# Addendum No. 06

April 11, 2024

## BAKERSFIELD COLLEGE STUDENT HOUSING (for DSA Project Name - New Residence Hall)

**PBK PROJECT NO.:** S2103400AR  
**DSA FILE NO.:** 15-C1  
**DSA APPLICATION NO.:** 02-122124

**MECHANICAL ENLARGED FLOOR PLAN - LEVEL 02 - SOUTH**  
**M1.23**

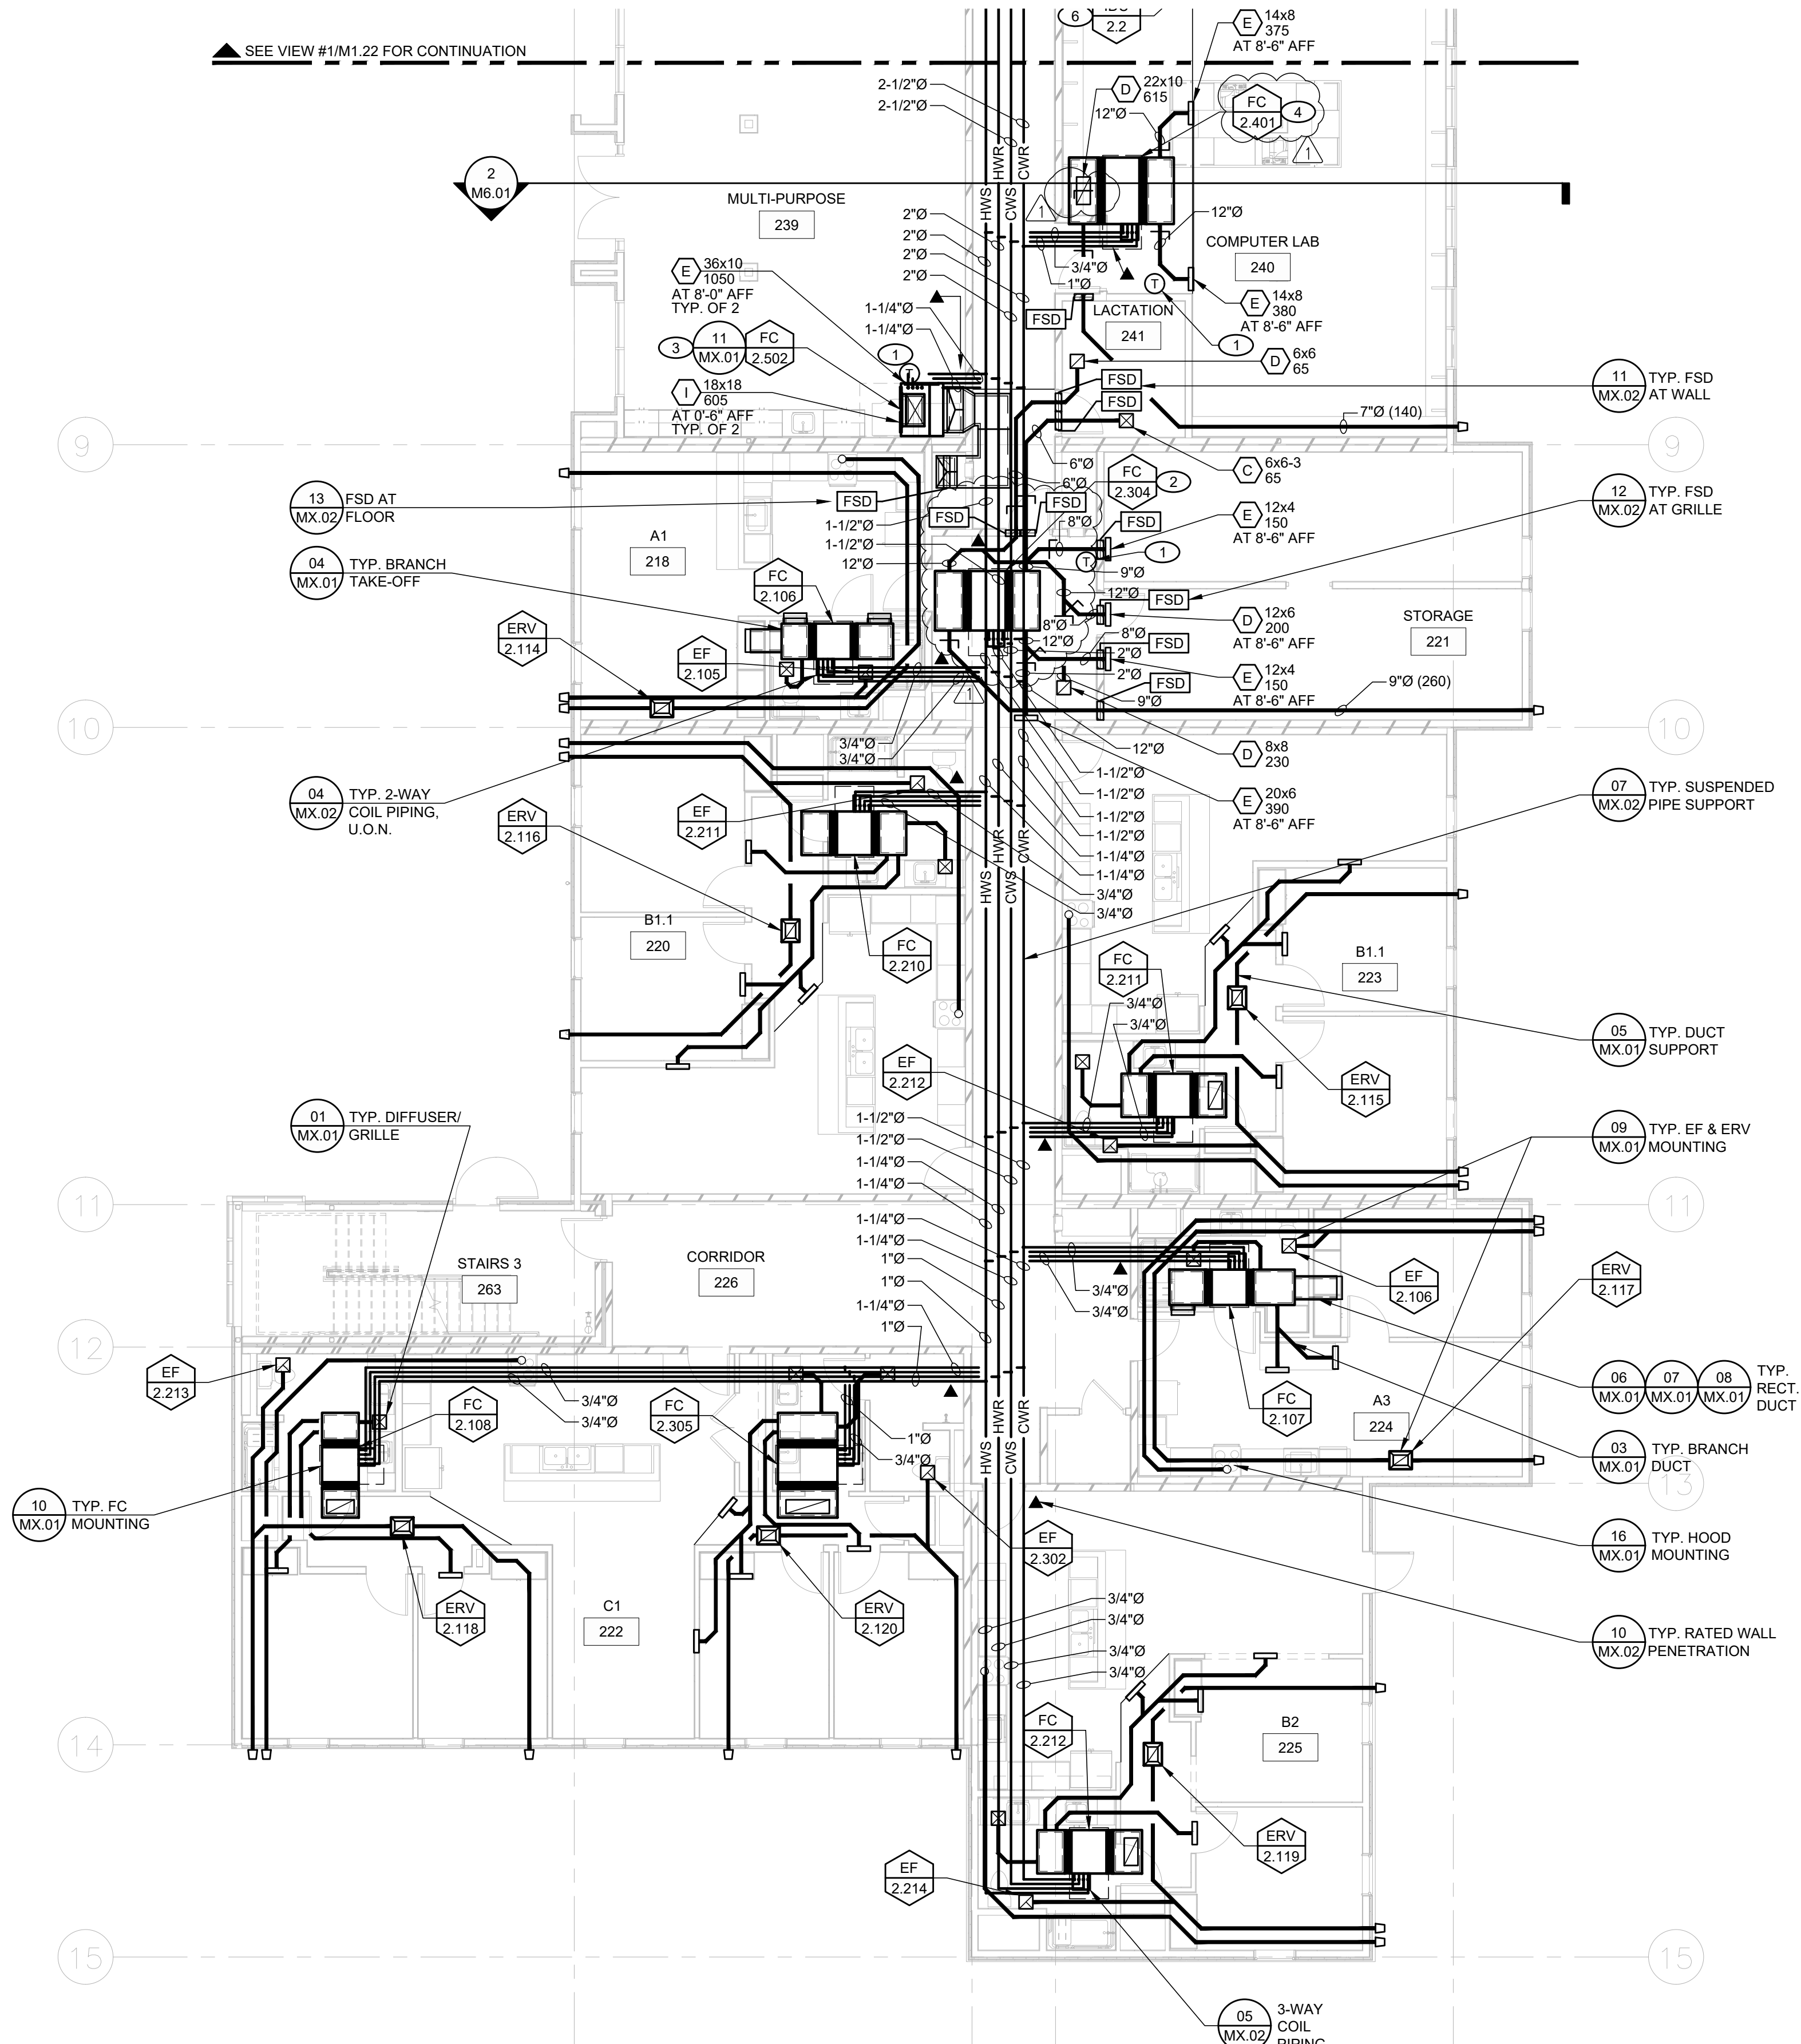
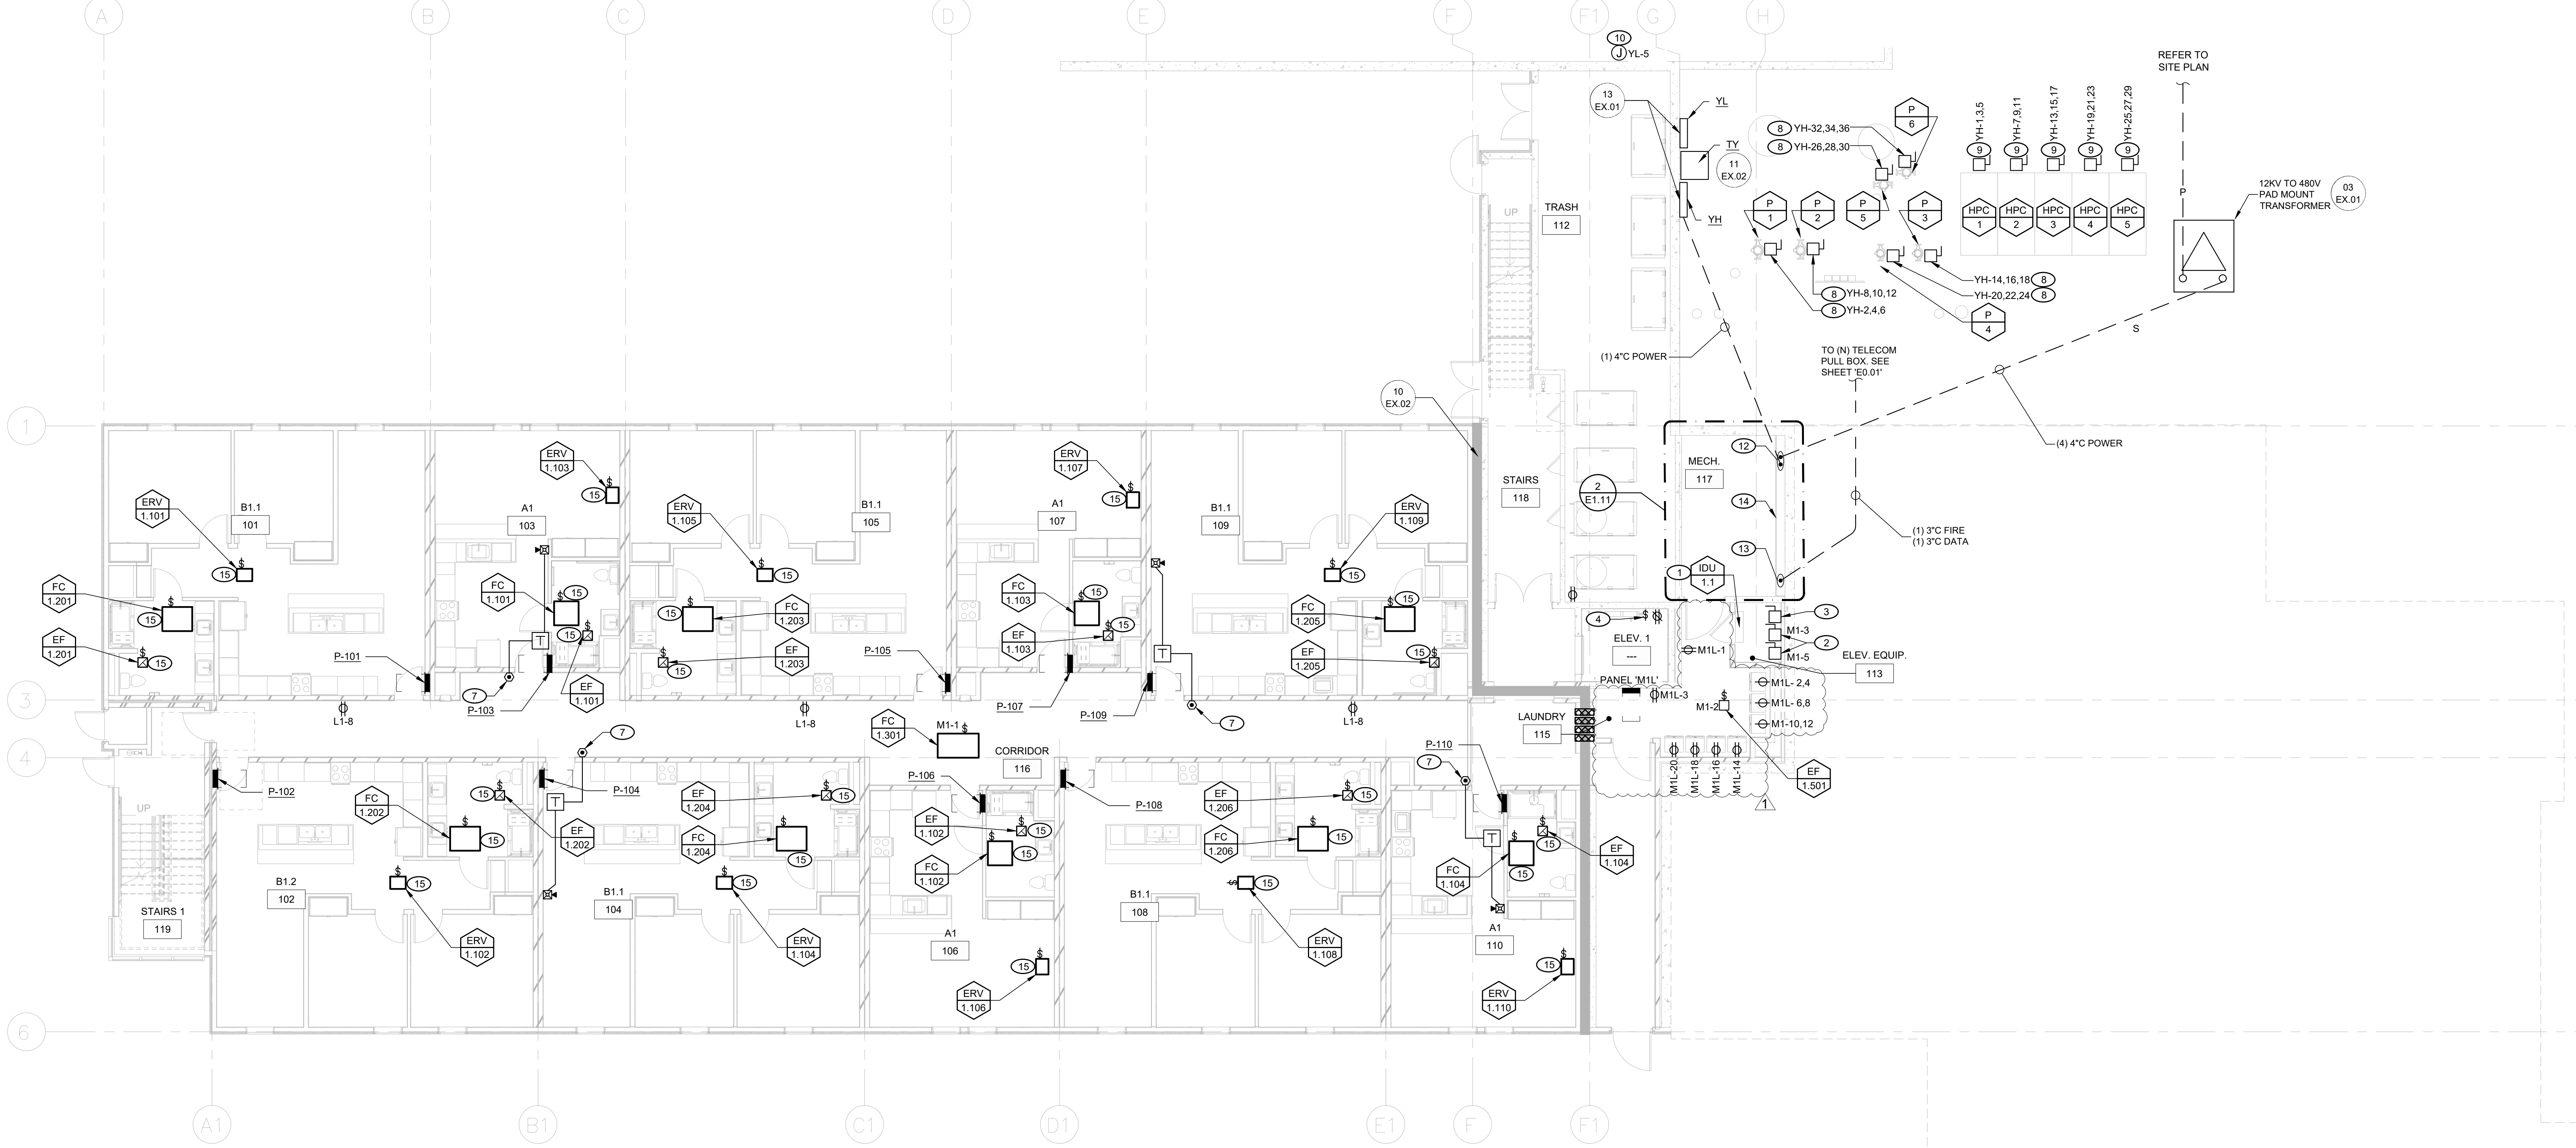
- AD6-40 M1.23 – MECHANICAL ENLARGED FLOOR PLAN – LEVEL 02 - SOUTH: ADD** Fire/ Smoke Dampers, Volume Control Dampers and keynote 4. See attached revised drawing M1.23 with all changes clouded.

**T1.11**

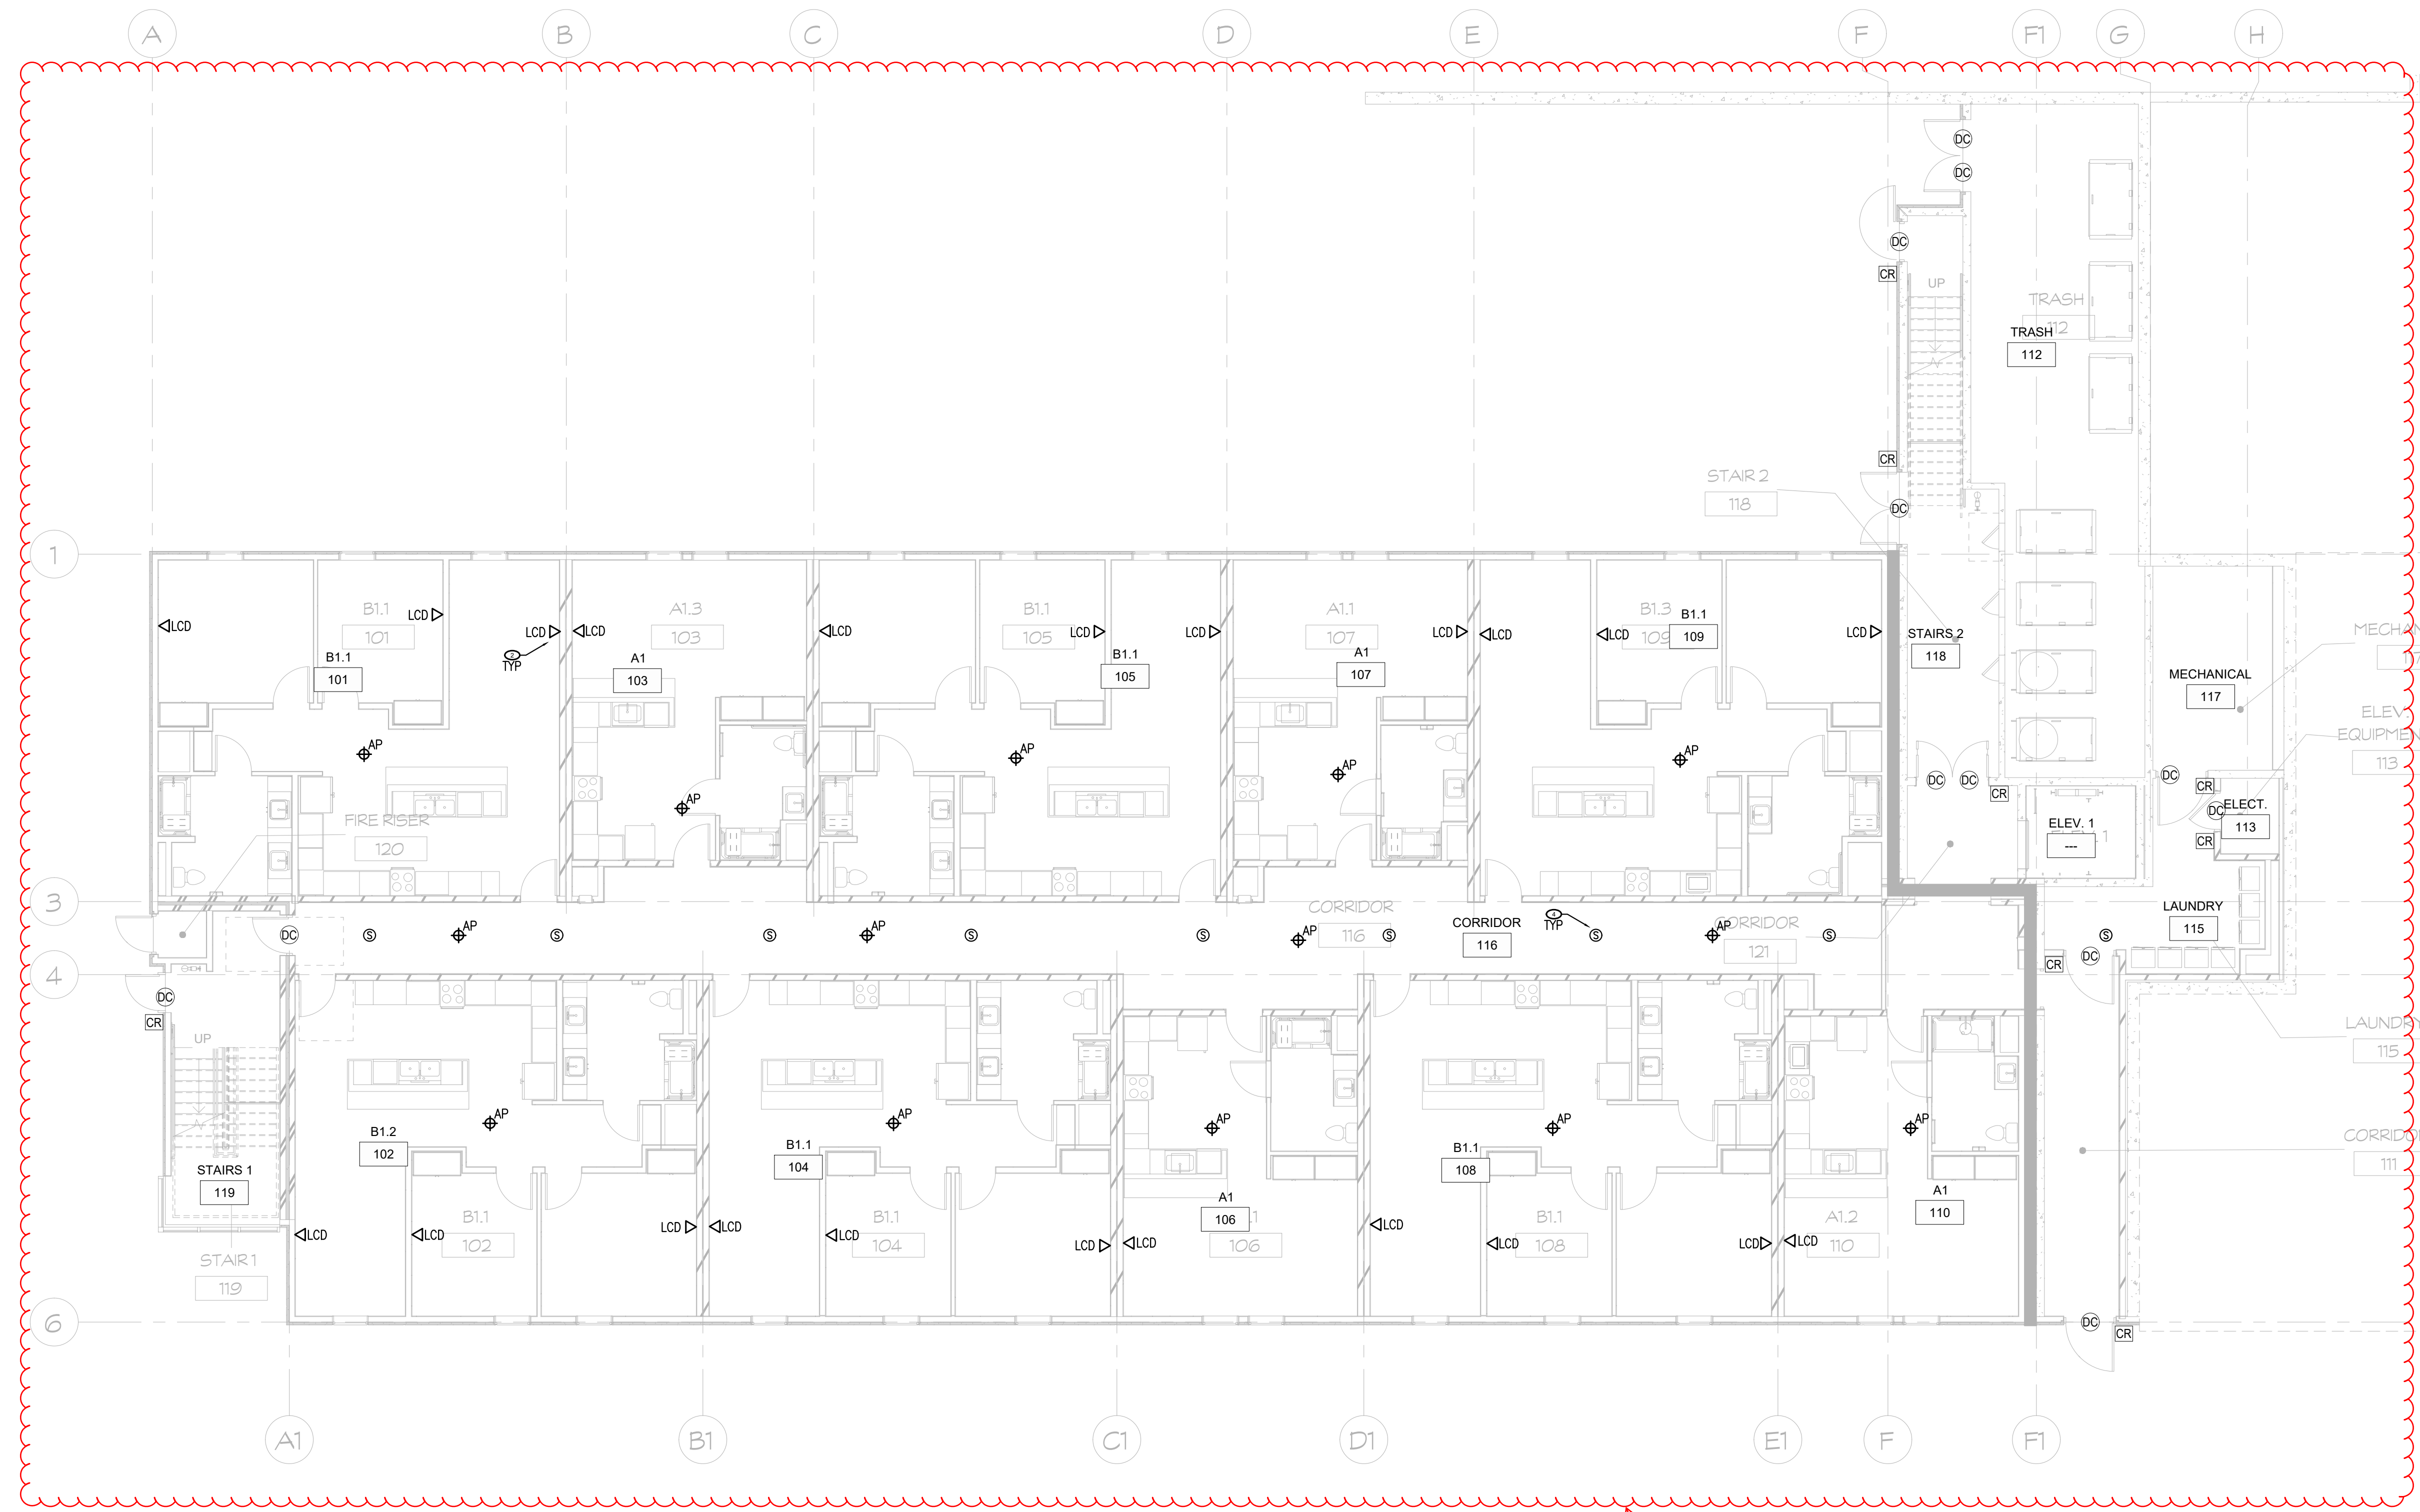
**AD6-57 T1.11, T1.11A, T1.21, T1.22, T1.31, T1.32, T1.41, T1.42 – TECHNOLOGY SHEETS** the technology sheets have been updated to remove D2 data drops in each room and to remove alarm motion sensors from the entry and corridor areas.
